A. ADMINISTRATIVE REPORT & DECISION

Merritt Short Plat

LUA16-000022, SHPL-A

SCALE:	1" = 40'
DATE:	DEC 16, 2015
SHEET:	1 OF 2

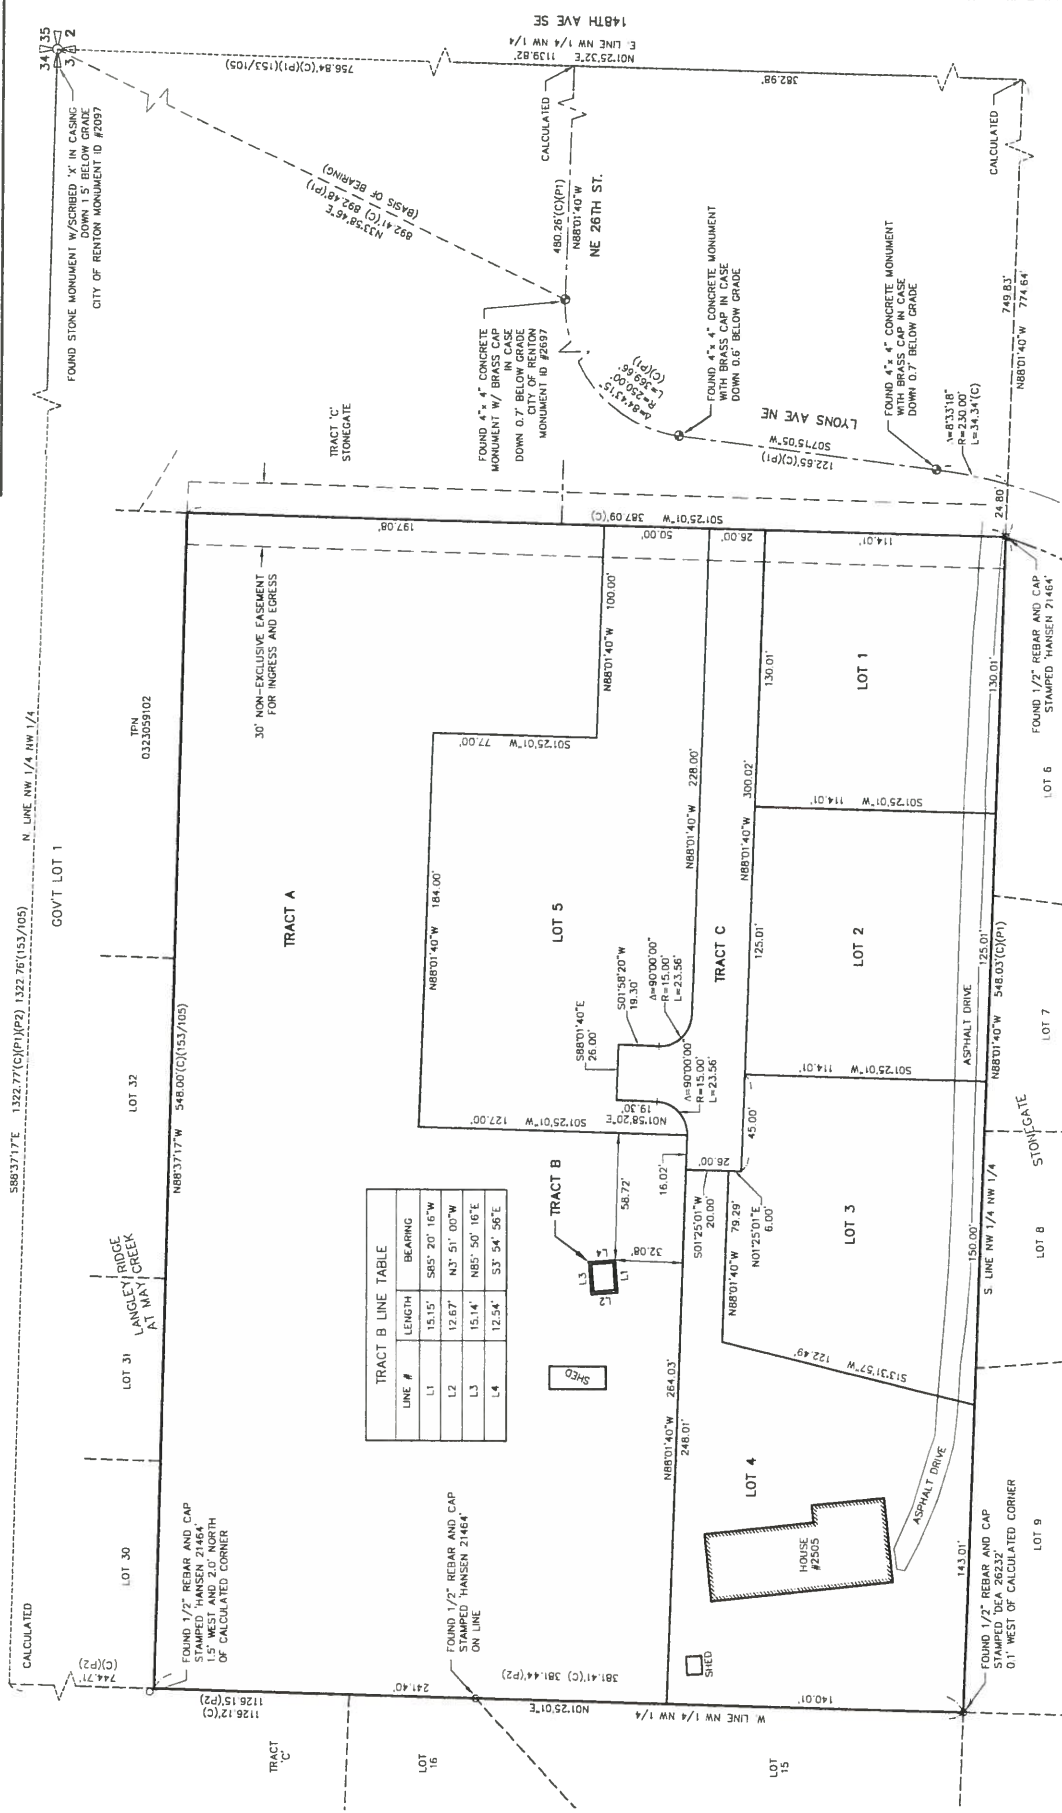
2. The short plat layout shall be revised, by adjusting the size of proposed Lots 1 – 3 or removal of existing impervious surface on Lot 4, to ensure that the existing residence proposed to remain on Lot 4 complies with the maximum impervious surface requirements of the R-1 zone. Compliance with this condition shall not be met by reducing the size of open space in Tract A. A revised short plat layout and impervious surface calculations shall be submitted to the Current Planning Project Manager at the time of Utility Construction Permit review for review and approval prior to issuance of the construction permit.

7. The shared driveway shall be extended further to the west eliminating the pipstem proposed to serve Lot 4, unless is it determined by the Fire Department that the driveway cannot be extended without a cul-de-sac.

14. The short plat shall be revised to either remove Tract B from the short plat or an access easement be provided to Tract B. The revised short plat shall be submitted at the time of Utility Construction Permit application for review and approval by the Current Planning Project Manager.
